# NATIONAL WEATHER SERVICE

## Engineering Handbook

AUTOMATIC OBSERVING (EHB-11)

MAINTENANCE NOTE INDEX - AUTOB

5. Zero Set Adjustment for the Rosemount Pressure Sensor.

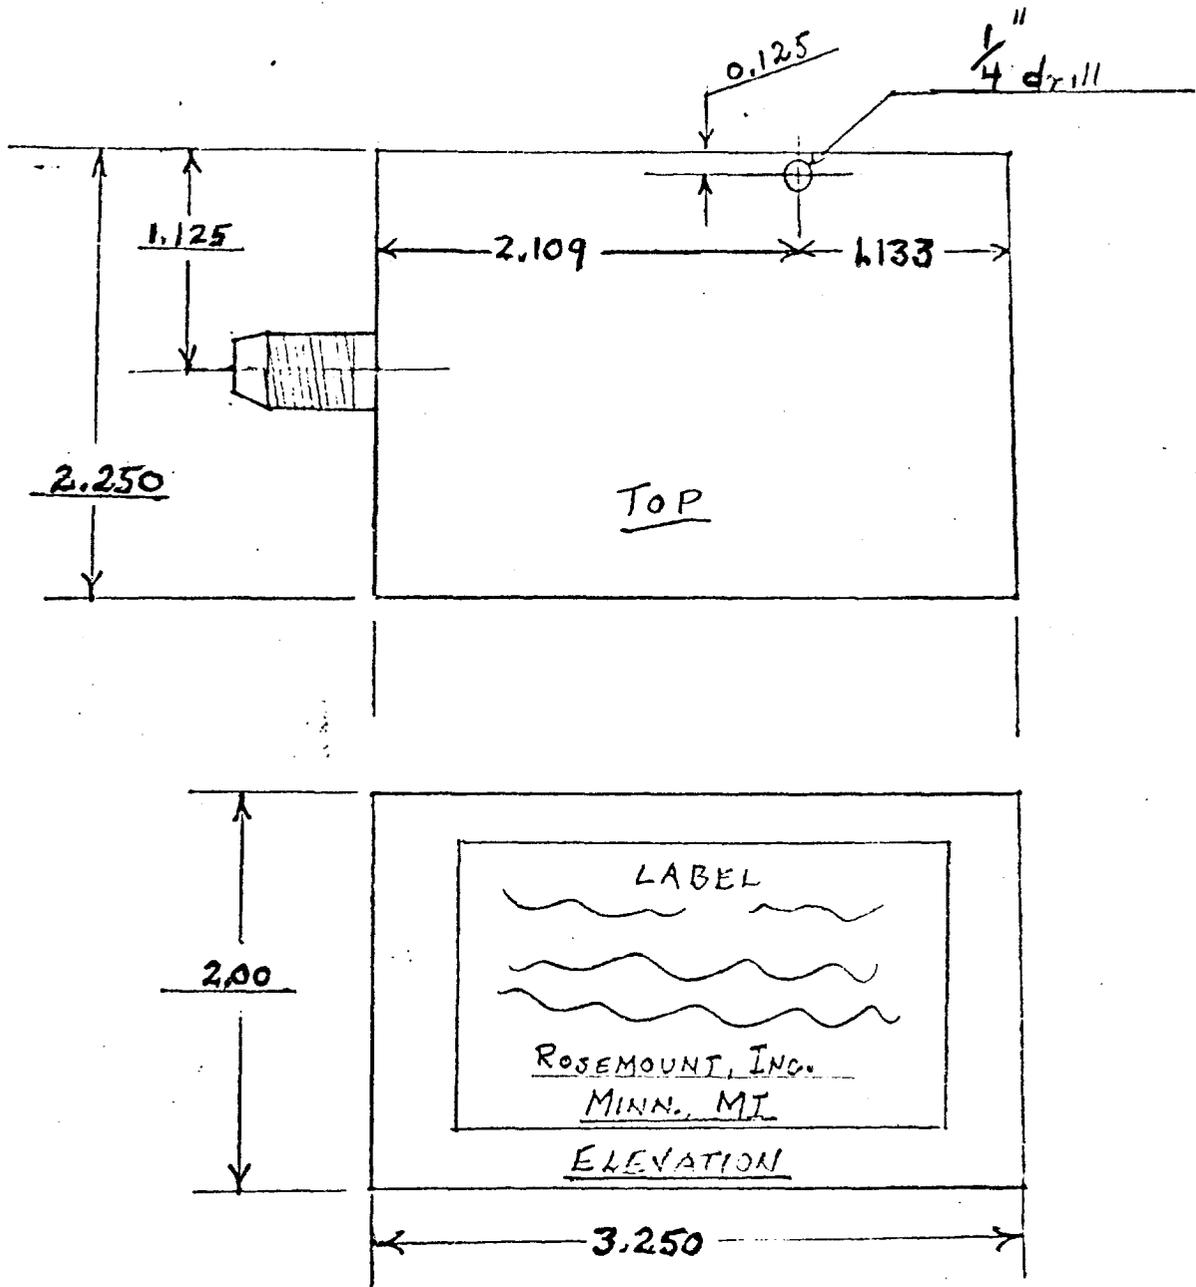
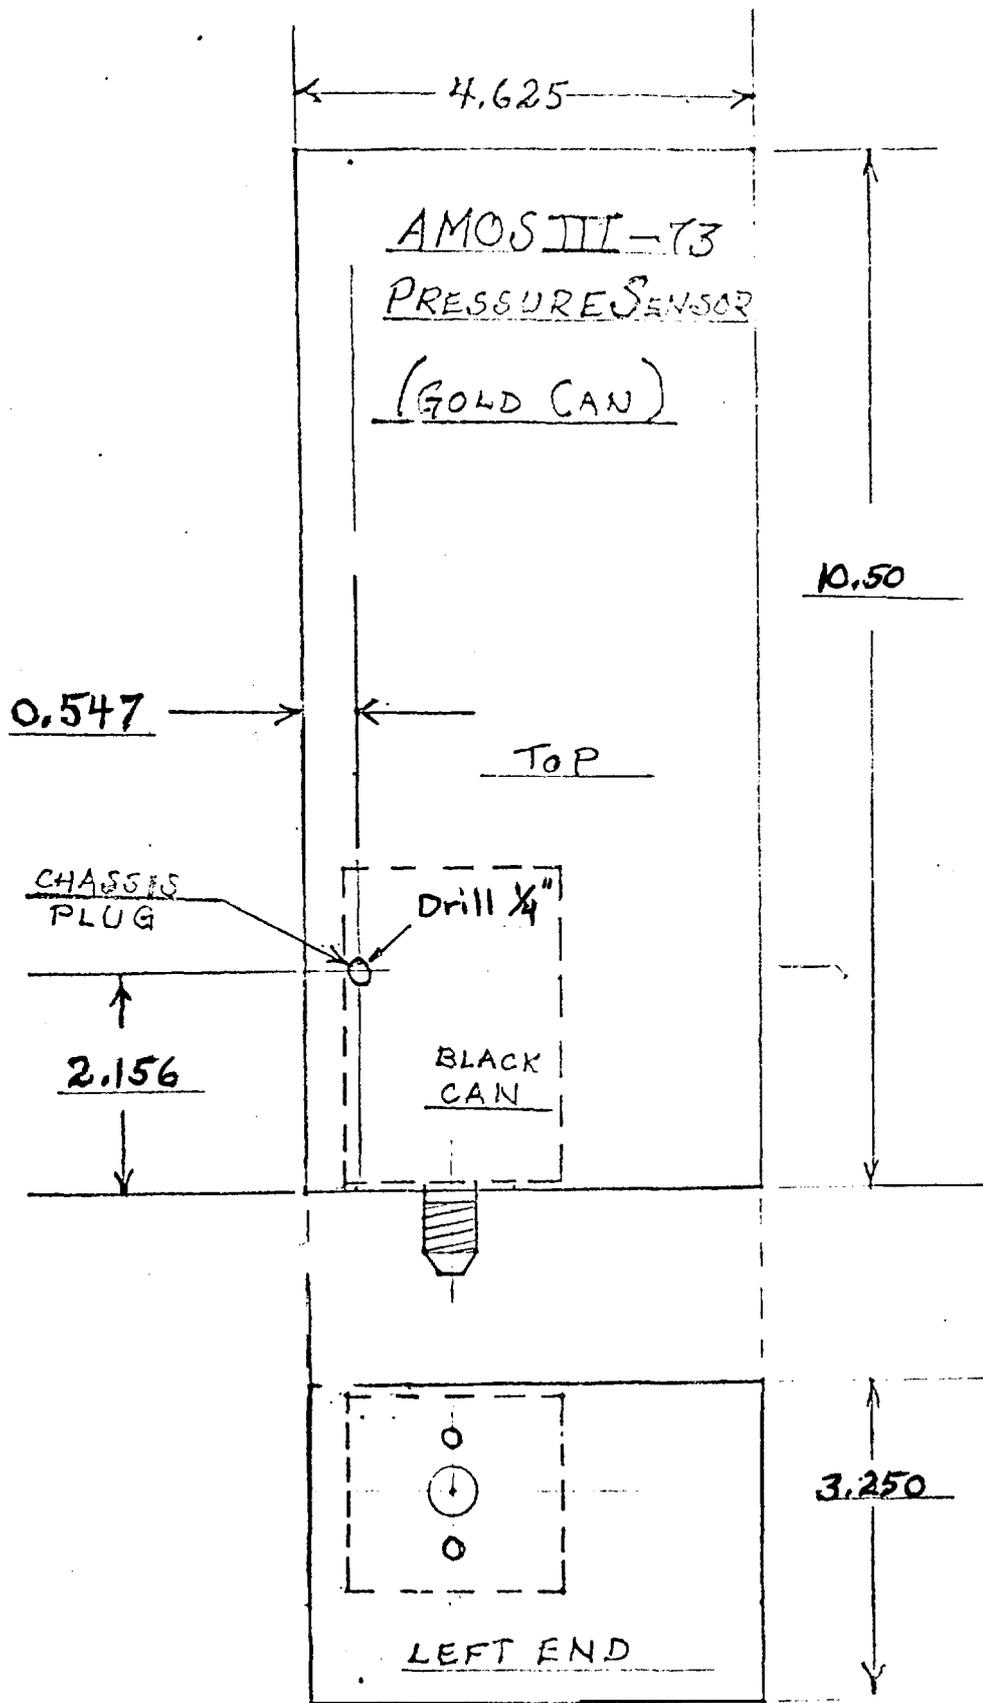
It has been determined that the Rosemount Pressure Sensor requires an on-site adjustment of the Zero Set potentiometer, R204. This adjustment will enable the ASI printout reading to agree with the station barometer, or Altimeter Setting Indicator. To accomplish this requires two changes:

First, relocate the Pressure Sensor 1A1, from its present location above the Processor 1A2 in the Unit 1 Console, to the lowest position in the Unit 1 Console.

Second, provide an access in the Transducer cover to permit adjustment of the Zero Set potentiometer, R204.

1. Dismantle the Pressure Sensor, 1A1, and remove the black box assembly labeled: Transducer, PS Pressure. Remove the black cover and locate the red potentiometer R204. Drill a quarter-inch hole in the cover that will allow access to R204 so adjustment can be made after the Transducer is reassembled in its cover. Place the Transducer, PS Pressure Assembly in the Pressure Sensor, 1A1 cover so that this cover may be drilled with a quarter-inch hole through which R204 may be adjusted when reassembled and placed back into the Unit 1 Console.
2. Adjust R204 to cause the ASI printed readout to correspond with the true altimeter setting value, as determined by the station barometer, or Altimeter Setting Indicator.

### AMOS III-73

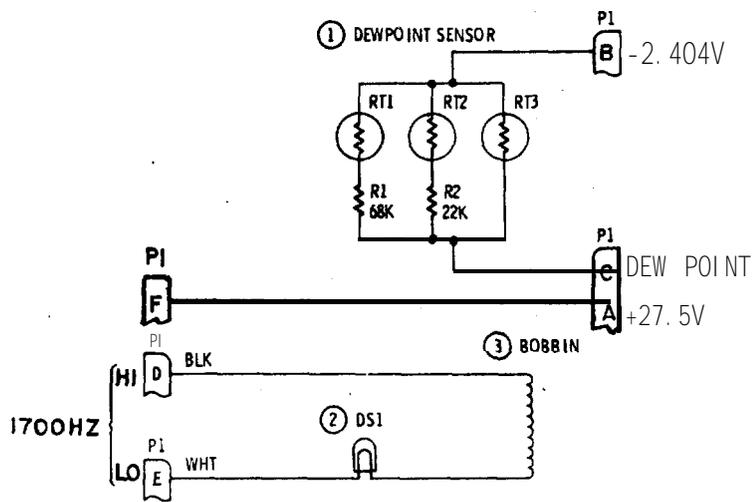
7. AMOS III-73 Preventive Maintenance Teletype Clock and Ten Second One Shot.

The following items of preventive maintenance instructions shall become a part of the maintenance procedure for the AMOS III-73 (Instruction Manual 11-103, Volume 1, Section 4, Subsection 4, Page 4-3).

1. Place unit #3 switch in Local position.
2. Use an oscilloscope to monitor TP107 on the processor chassis. (shift from TW card)
3. Install test jumper on TW module.
4. Place the test mode switch (S1 on the TW module) in the "run continuously" position (bat handle at center).
5. Turn teletype off. (Saves paper)
6. Simulate a station call by momentarily depressing S2 on the TW module.
7. As the AMOS cycles continuously, adjust the oscilloscope sweep and gain controls to obtain a stable square wave having the following characteristics:
  - a. Amplitude - +0.2 to ±4.5 volts, PW = 4 MSEC
  - b. Period - 100 msec.
8. If frequency is not the above value, adjust R2 (2K), located on top of the TW module in the vicinity of the test jumper, until the period is 100 msec.
9. Turn on Teletype and insure that the AMOS message will print correctly.

1. Place unit 3 (Local/Long Line) in Local position.
2. Turn off processor power.
3. Remove the wind speed card (1A2A11).
4. Remove the test jumper from the TW module and place S1 in the 'normal single observation' position (bat handle towards rear of chassis).
5. Reapply power to the processor.
6. Using a stop watch or sweep second-hand time piece for timing, initiate a station call. (Insure that the test jumper is not in place).
7. Observe the time the station call indication (DS102) remains operative (flickering) after the station call up. Note that if the Teletype is on, the AMOS message will be correct up to wind speed, then zero's will be printed until the timer runs out. It should be a minimum of ten seconds and not over 40 seconds.
8. Turn Processor power off.
9. Replace wind speed card.
10. Turn Processor power on.
11. Place unit #3 in Long Line position.

Power Distribution, Page 2-37: 2PS2 Temperature/Dewpoint Sensor Power Supply,

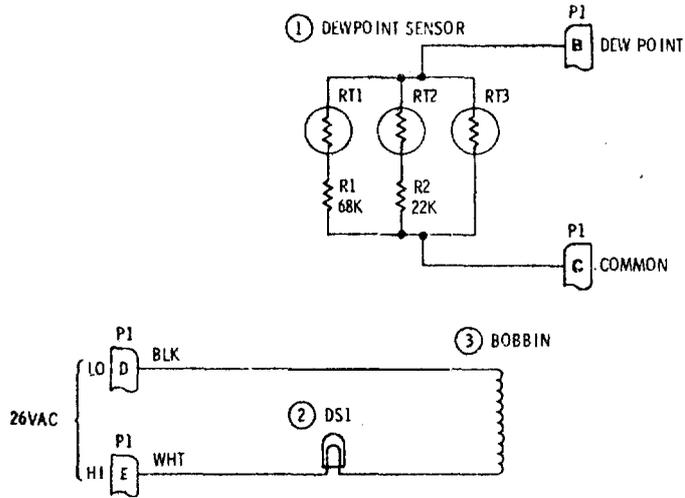
The attached Dewpoint Sensor Schematic shall replace the existing schematic in the AMOS Instruction Manual 11-103, Volume 2, Page 2-257.

Make pen and ink changes as follows (these changes are in addition to those submitted in Maintenance Note No. 8):

change J602-F to read: J602-E.

2PS2 Temperature/Dewpoint Sensor Power Supply, Page 2-263 to read:

Steps down applied AC input to 6VAC output for operation of the Dewpoint Sensor. The sensor plugs in J602 and J601, and the A and C connection points are connected to J603 and B and C to J604, which provide interconnection between the processor and sensor,

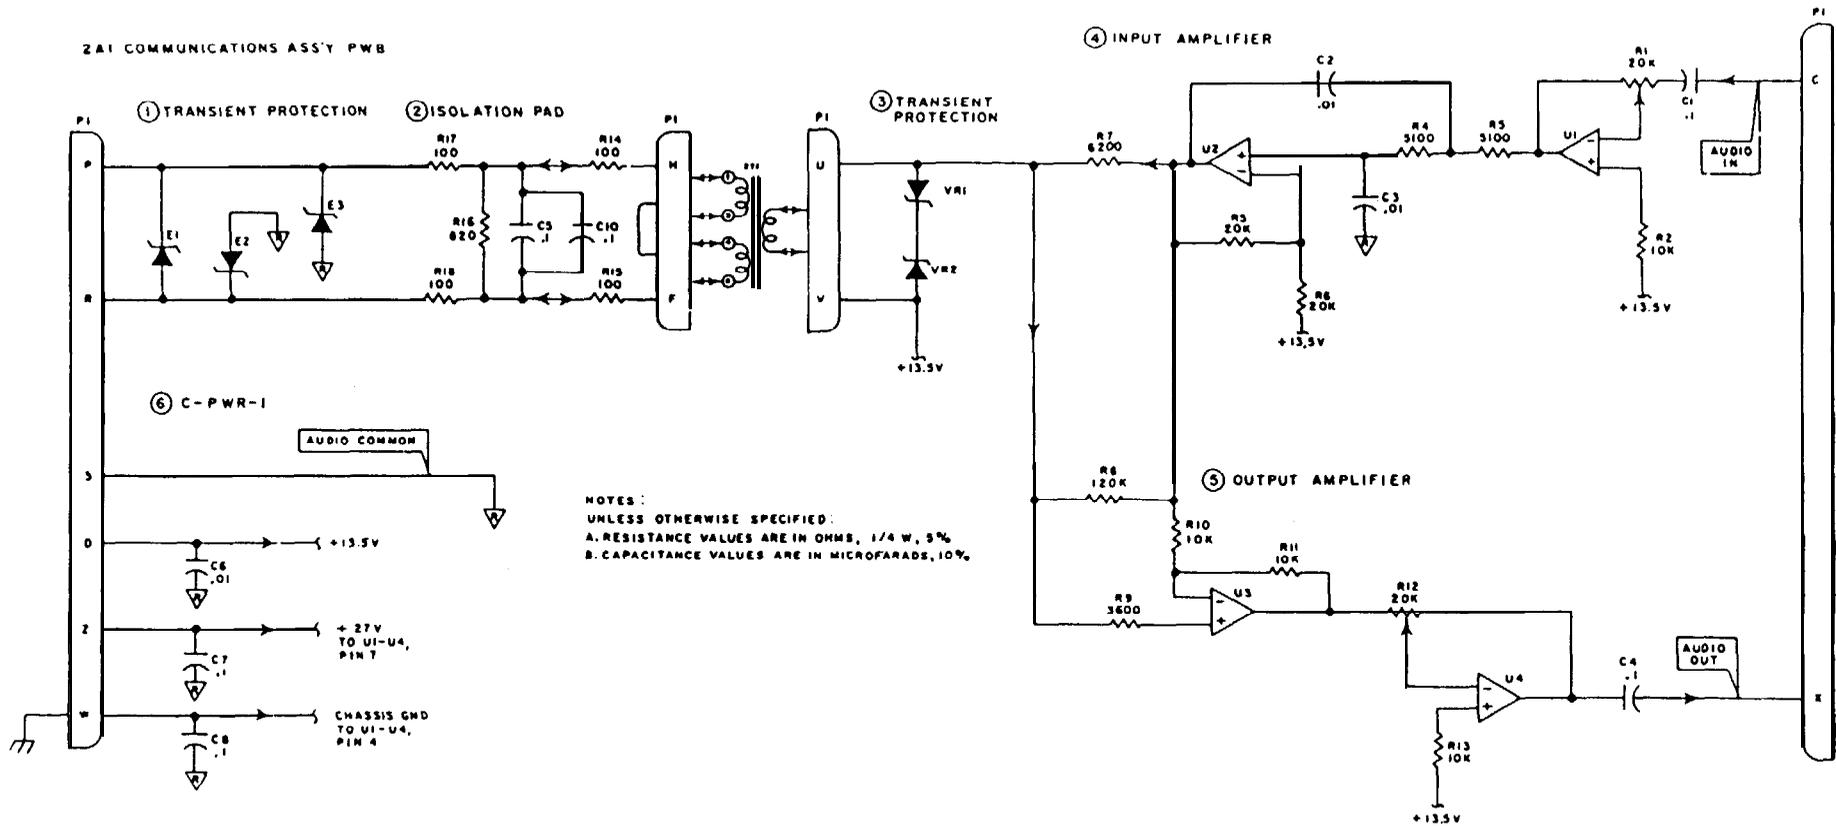
The purpose of this procedure is to provide an alternate method of adjustment when only one technician is available. It requires only one round trip to the RAMOS.

1. Begin at the MED. Temporarily disconnect the telephone lines and install the 600-ohm resistor in their place between TB102-2 and TB102-4.
2. Depress and hold the reset pushbutton. (The single technician can hold it depressed with a piece of tape or a stick.)
3. Adjust 1A3R47 for 0.7 Vpp (-10dBm) across the telephone line, TB102-2 and TB102-4. (MED Transmit)
4. Remove the 600-ohm resistor and reconnect the telephone lines, thus reversing Step 1 above.
5. Proceed to the RAMOS. Temporarily disconnect the telephone lines and install the 600-ohm resistor in their place between the TB2-4 and TB2-5 in the Communications Assembly.
6. Adjust 2A1R1 for 0.7 Vpp (-10dBm) across the telephone line, TB2-4 and TB2-5. (RAMOS Transmit)

7. Remove the 600-ohm resistor and reconnect the telephone line, thus reversing Step 5 above.
8. Turn off Basic Electronics Assembly using switch 1A1S101 (at lower right of chassis).
9. Adjust 2A1R12 for 3 Vpp between TB1-2 (Ground) and TB1-3. (RAMOS Receive),
10. Turn on BEA (1A1S101), thus reserving Step 8 above.
11. Return to the MED. Release reset pushbutton, thus reversing Step 2 above.
12. Adjust 1A3R57 for 3 Vpp between 1A3J2 and E101 (Ground stud at chassis rear). (MED Receive),
